Report Title:	Brocket Task and Finish Group
Contains Confidential or Exempt Information?	NO - Part I
Member reporting:	Councillor Gerry Clark, Chair of Task and Finish Group
Meeting and Date:	Cabinet Prioritisation Sub Committee 17 May 2017
Responsible Officer(s):	
Wards affected:	Boyn Hill

THE BROCKET . BOYN HILL AVENUE . MAIDENHEAD
FEASIBILITY STUDY

Comment by Cllr Claire Stretton on the Feasibility Study conducted by CSK Architects to ascertain its suitability for use as a residential scheme or mixed-use scheme with the Registrar's Office

RESPONSE TO REPORT PREPARED BY COUNCILLOR CLAIRE STRETTON – VERSION 3

1592 / SK04 --

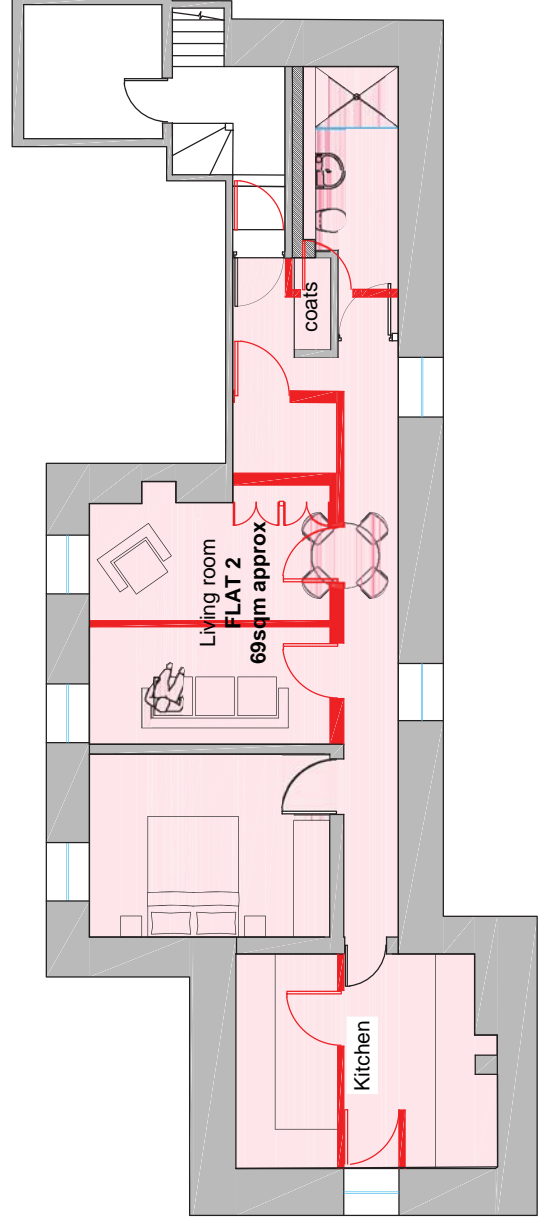
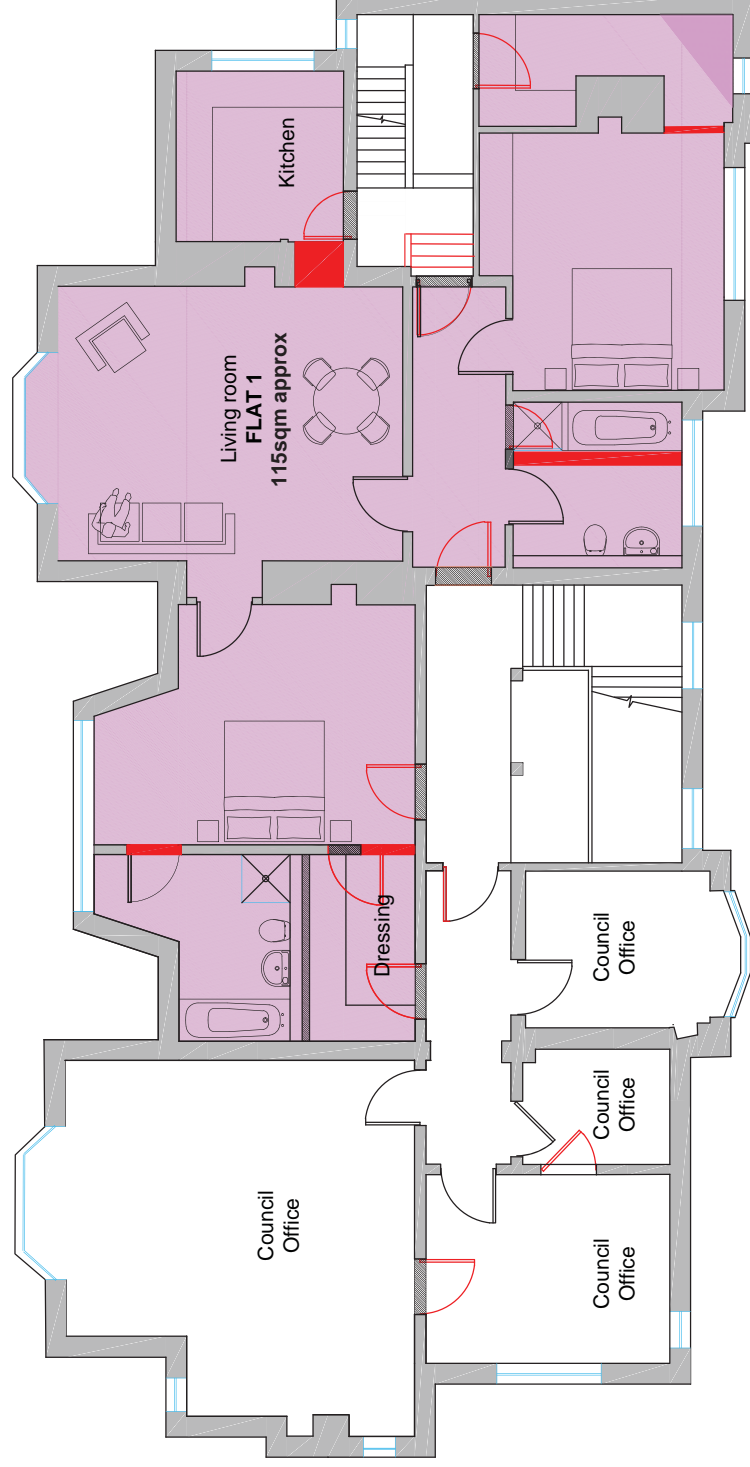
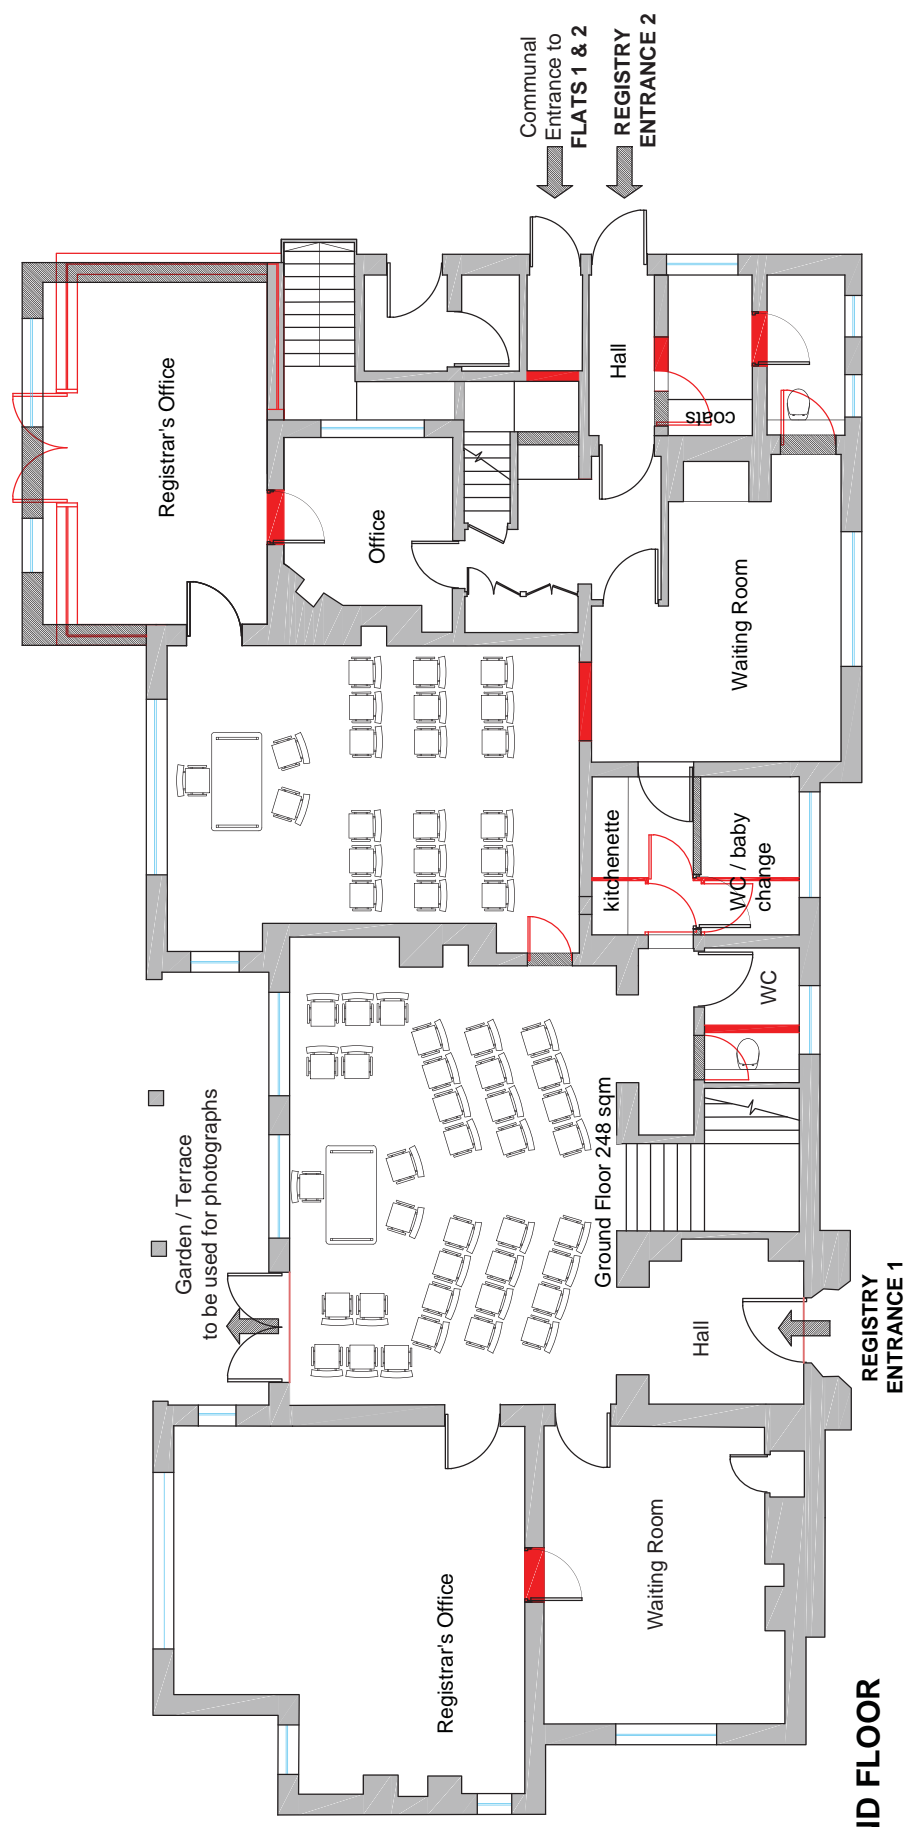
Advantages: This layout makes use of the principal reception room as a public space. The panelled room is a handsome room and taken at face value it would appear to suit the function of a registry office.

It is possible to accommodate two different size wedding parties. They have their separate waiting areas.

Disadvantages: The main room isn't that big – it can't accommodate the 48 visitors usually needed for a large marriage. Because it is a listed building it is not a simple case of knocking two rooms together to create a larger room. The integrity of each of the main rooms with their associated cornice/panelling/skirting etc must be respected.

There is limited options to increase the parking on the site, beyond 12 spaces. Depending on the status of the Copper Beech on site, even this number of spaces may not be possible. If two wedding services were being conducted simultaneously, as the plan suggests, parking problems will be even more problematic than option 3.

The existing principal stair must be retained and it must lead somewhere. This necessitates commercial space at first floor.

There is a vertical overlap between commercial space and residential accommodation which complicates acoustic / fire separation.

BROCKET MAIDENHEAD	1:125 @ A3	08/2016
REGISTRY OFFICE, MEETING ROOMS AND CARETAKER FLAT

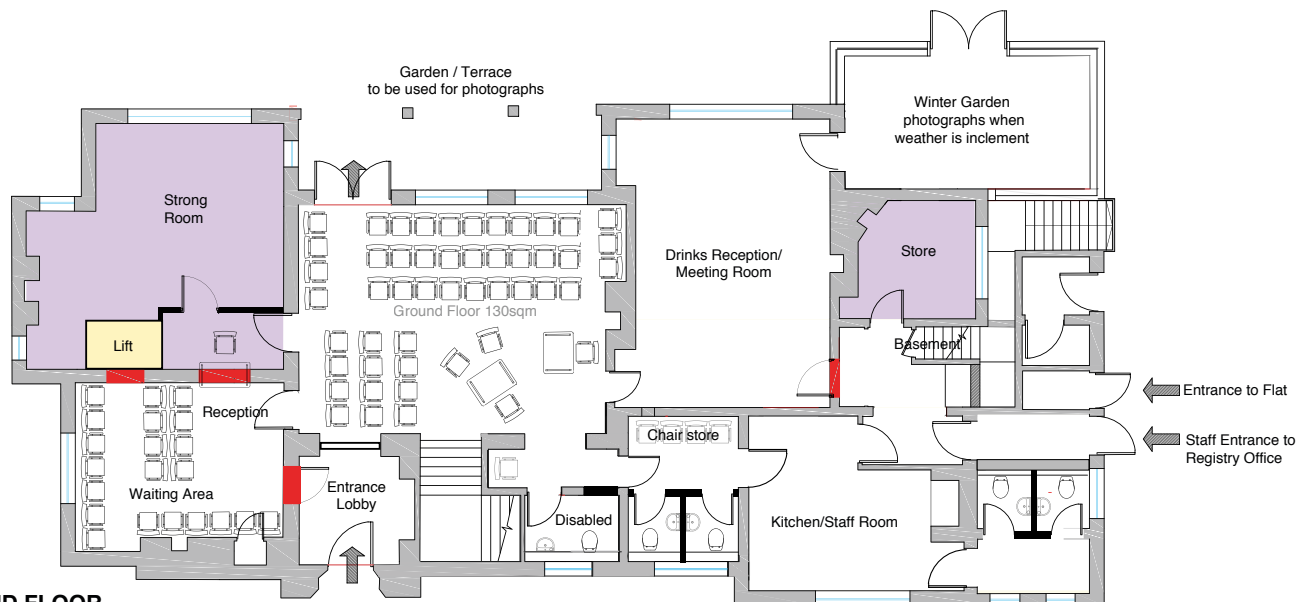
- 1 A new doorway from the Entrance Hall to the Reception and Waiting Area and installation of glass screen or door between the Entrance Hall and the Ceremony Room

- 2 Secure shutter between Reception and receptionists office with wall added to provide a Strong Room behind.
- 3 A small passenger lift to enable disabled access to the first floor, access from the Waiting Area.

- 4 Suitable toilets installed, including for the disabled on both ground and first floors.
- 5 Conversion of the roof space into a one-bedroom Caretakers Flat with suitable fire and acoustic separation in the floor.

- 6 Landscape the Gardens to improve the setting of the Listed building and provide for Photographs.
- 7 (Optional see page 4) Extending the Ceremony Room by moving one wall out to meet the existing roof.

The report indicates proposed layouts for the building with usage as a Registry office. The plans have been assessed within the context of the listed building in terms of building fabric and likely acceptability of the proposed interventions.

The proposed usage of the building puts it within the public realm and as such it will then need to be fully accessible. It is proposed that the main ceremonial room and all public access is, quite rightly, via the existing main entrance. This is two steps up from the external drive level to height of 280mm. In order to be fully DDA compliant a ramp length of 3.36m would need to be installed to allow for wheelchair access (assuming a 1 in 12 ramp gradient). This would then obstruct the driveway and result in the loss of parking bays to the front of the building – increasing the pressure for on-street parking and / or a parking area in the rear gardens.

The main hall itself is quite fine in its detailing and scale and it is unlikely to be able to be extended into the external verandah area as it will change the proportion of the room. If wedding ceremonies are proposed then they will need to be arranged within the confines of the existing space available. Shown at face value, this looks as quite tight in terms of access and chair proximity. A mock layout has been set up in-situ to establish exactly how many chair spaces can realistically be accommodated in the space – please see attached photos. This indicates that the main hall can only facilitate a maximum of 32 people. This is significantly lower than the required 50 that has been advised by the current Registrar.

To conclude, we still consider the proposed interventions to facilitate a registry office within the listed building would not be acceptable in terms of Conservation policies. The building was originally designed as a dwelling and as such the rooms are, whilst larger than average for a house, domestic in their scale and not suitable for use as a public building. The Registry office requires a large ceremony room which the Brocket is unable to provide. Alternative public uses will have the same issues of having to adapt the building to be fully accessible, with the intervention of ramp / lift etc. The issue of additional parking requirements will also apply leading to further on-street parking or the destruction of the rear garden, loss of part of the listed garden wall and removal of important tree screening. All of which would no doubt be of concern to the local residents and also be detrimental to the fabric and setting of the building.

Optional extension to the Ceremony Room

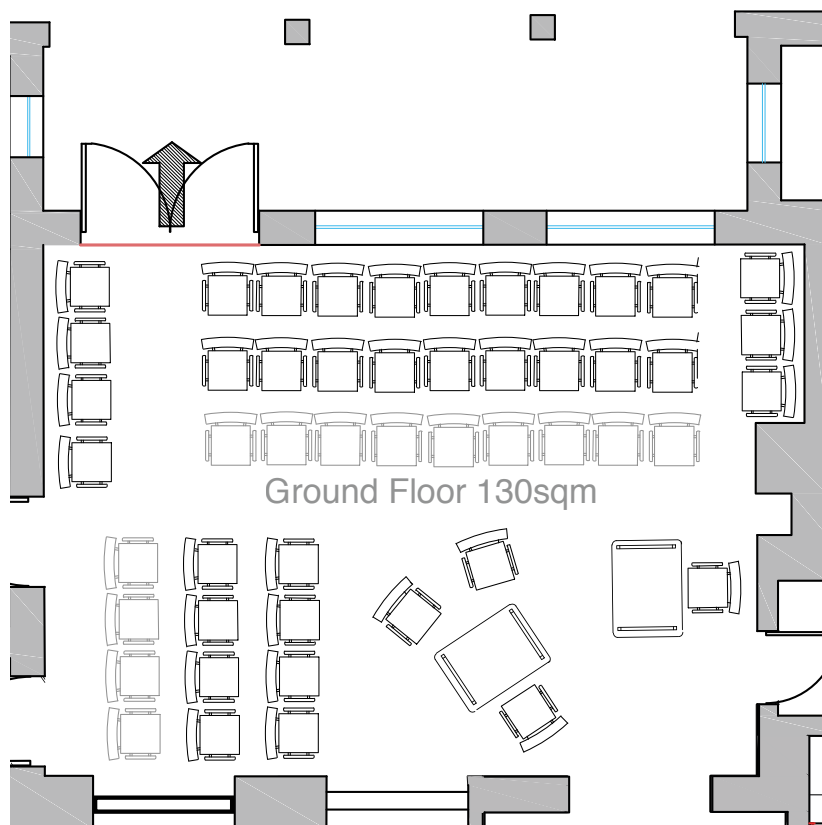
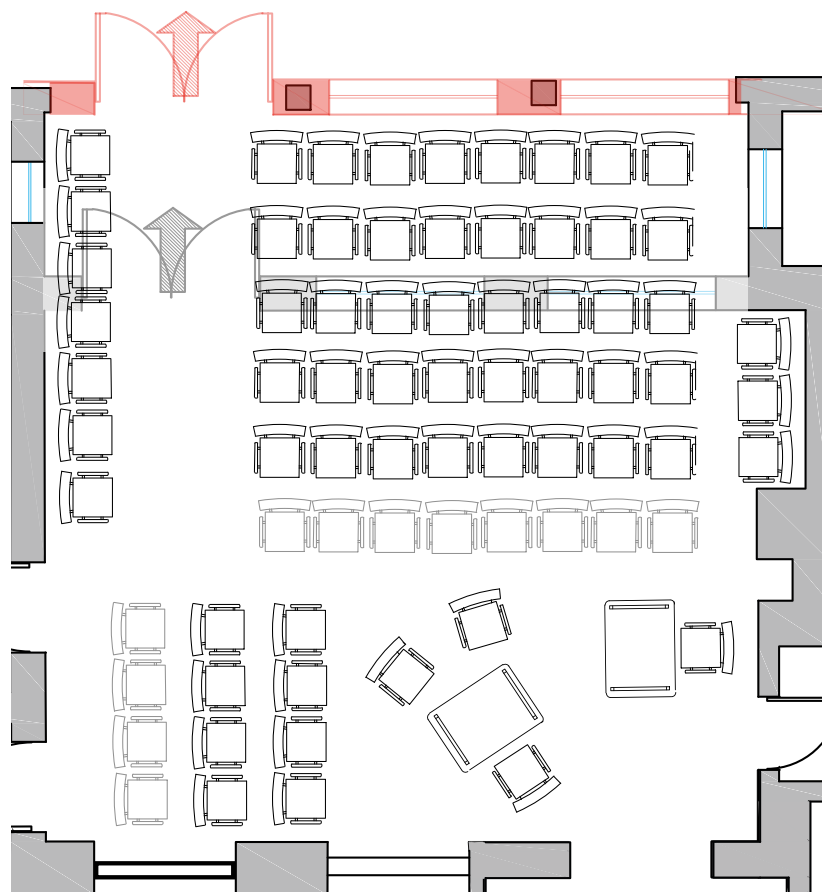
By turning the orientation around from the architects suggested layout, this area could comfortably seat 35 Guests with Bride and Groom, with a maximum of 48, by adding the rows shown in grey. Seating in a Church or similar is unlikely to provide much more leg room than this. The signing of the Register takes place inside this room, as now.

If the Conservation Officer felt that, to enable more public use of this building, it could be appropriate to extend by relocating the current wall and windows to where the pillars currently stand which support the overhanging roof, then this area could comfortably seat 60 Guests with Bride and Groom, with a maximum of 72, by adding the rows shown in grey.
